Errata to MPC8349EA PowerQUICC II Pro Integrated Host Processor Family Reference Manual, Rev. 1

This errata describes corrections to the *MPC8349EA PowerQUICC II Pro Integrated Host Processor Family Reference Manual*, Revision 1, which is the initial version of this reference manual. The MPC8349EA contains an embedded Power Architecture® core. For convenience, the section number and page number of the errata item in the reference manual are provided. Items in bold are new since the last revision of this document.

Figure 4-5. Loading Reset Configuration Words from Local Bus

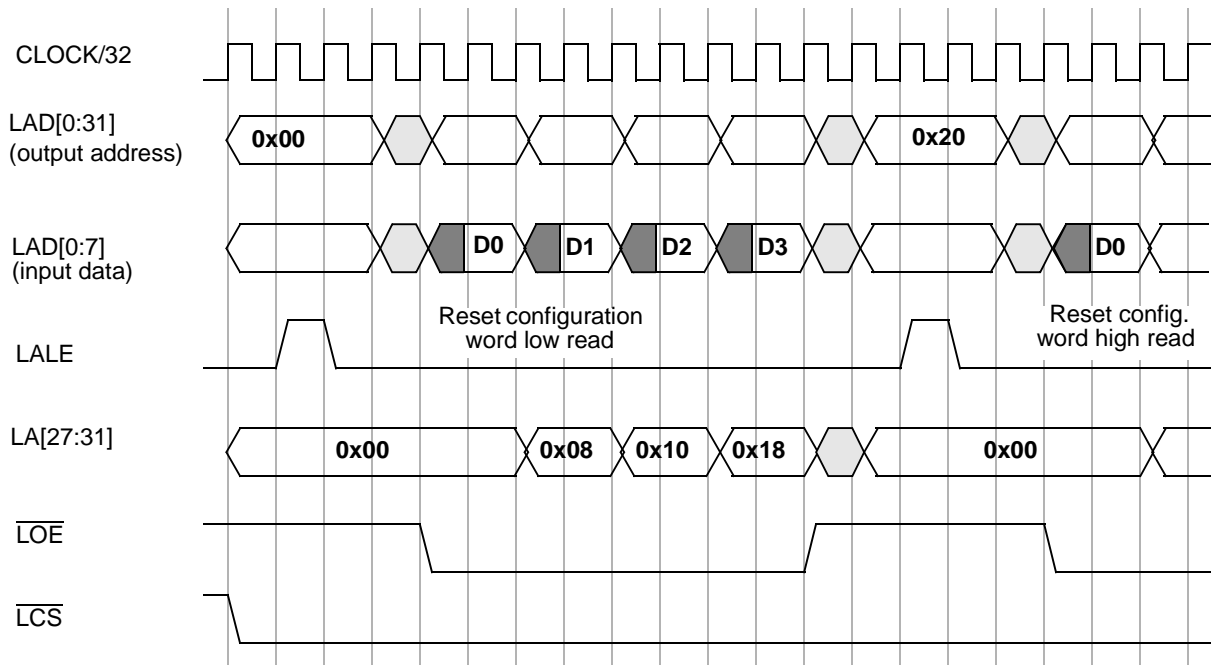
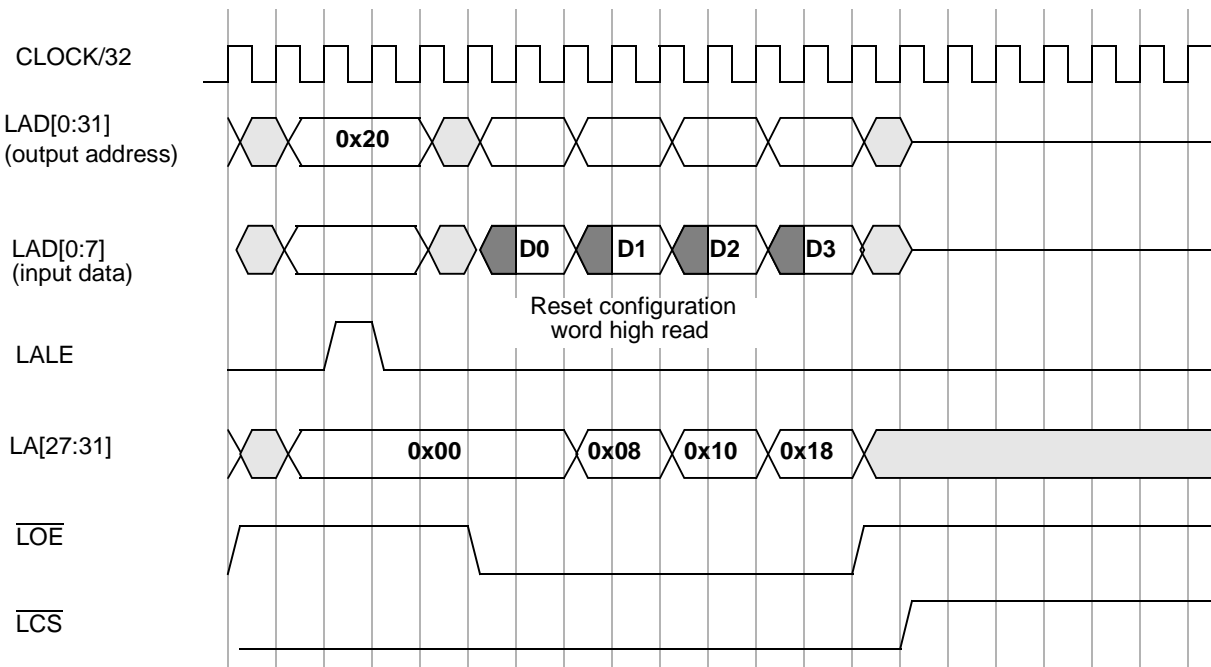
Replace figures 4-5 and 4-6 with the following updated figures:

Figure 6-3. Arbiter Transfer Error Register (ATER)

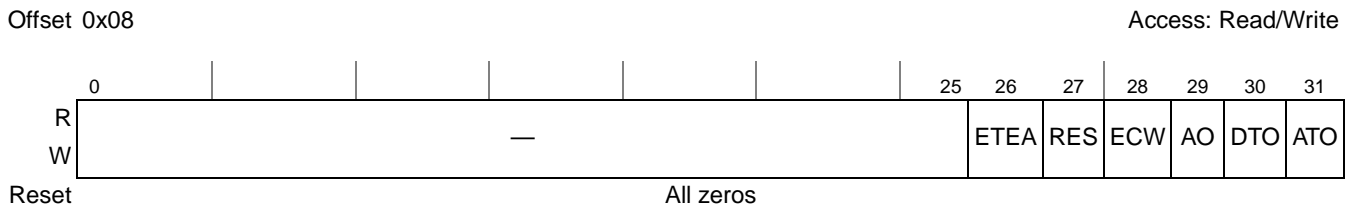
6.2.3, 6-5 Add the following section. Renumber subsequent sections accordingly.

Arbiter transfer error register (ATER) specifies, which kind of events are considered as error events. If event is defined as non error event, it also won't be reported neither in event register nor in event attributes and address registers. For transfer types, that are not defined as error events, arbiter also does not end address/data tenures. [Figure 6-3](#) shows the fields of ATER.

Figure 10-32. External Termination of GPCM Access (PLL Enabled Mode)

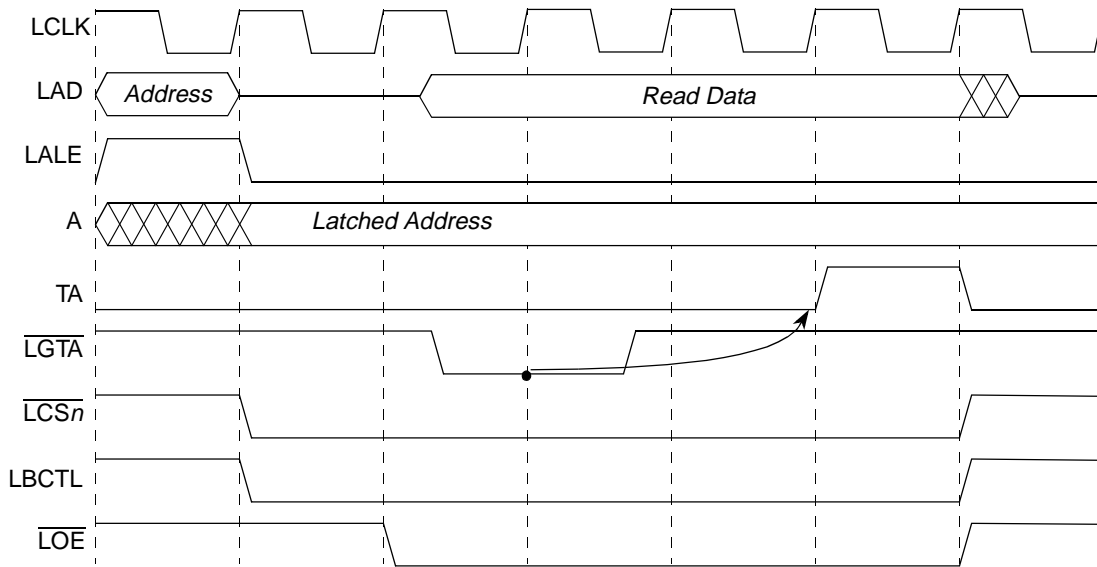
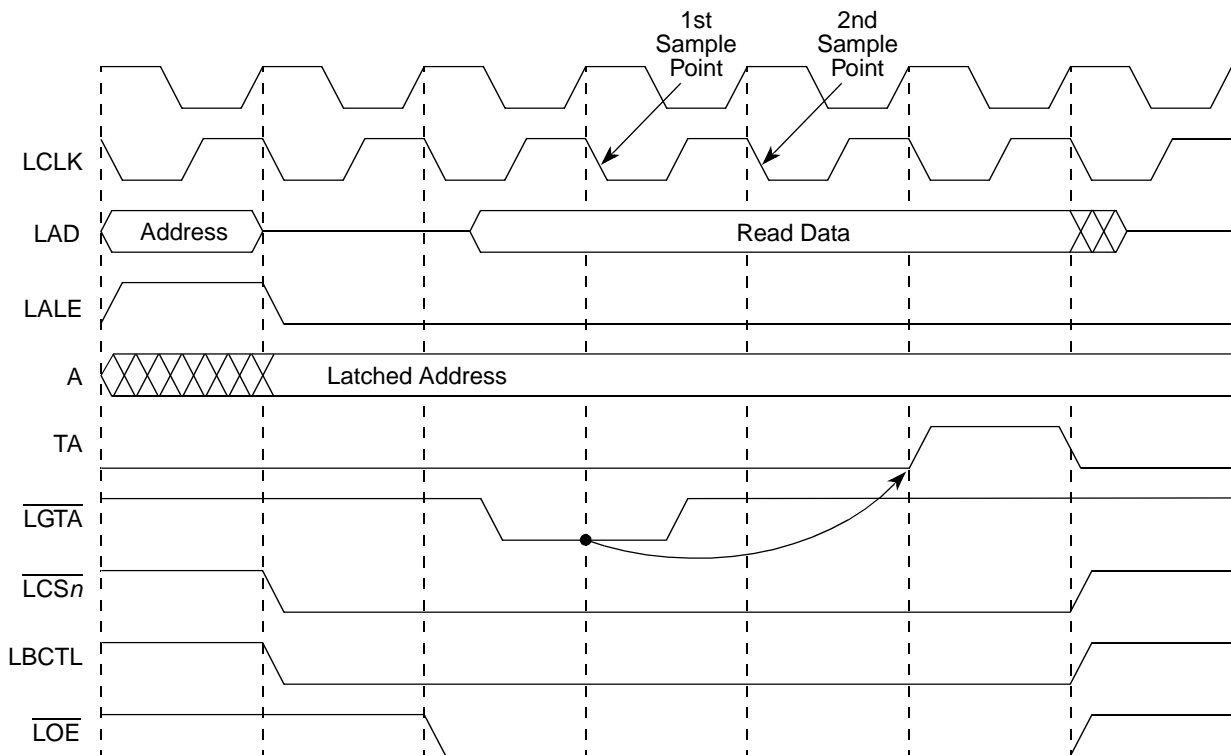
Replace Figure 10-33, “External Termination of GPCM Access,” with the following two figures:

Figure 13-32. PIMMR Base Address Configuration Register

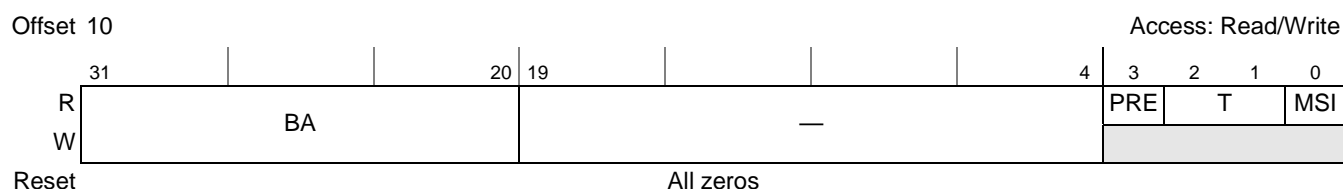
13.3.3.13, 13-37 Modified PIMMR[BA] as follows:

Figure 20-71. JTAG Interface Block Diagram

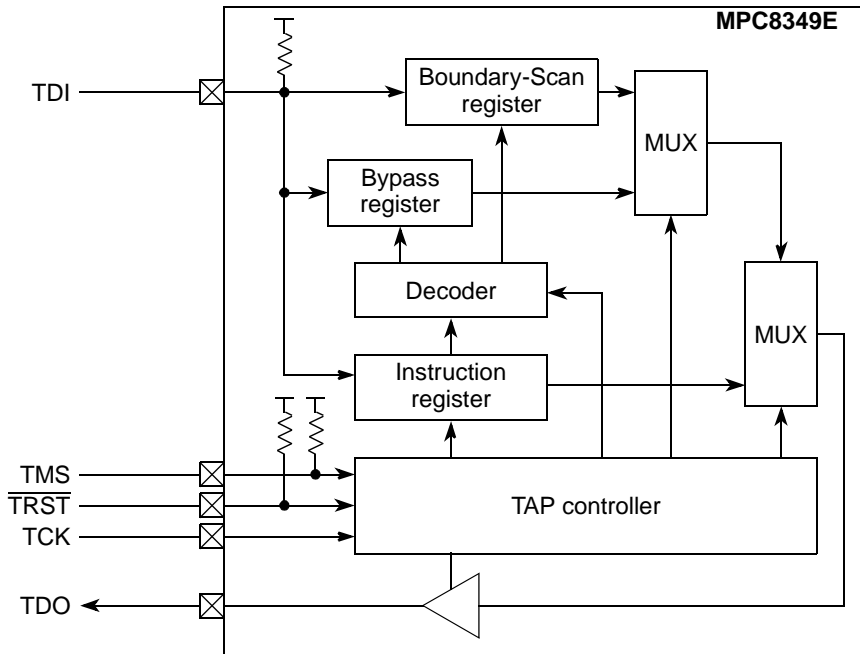
Removed resistor from TCK signal in Figure 20-1. Figure should appear as follows:
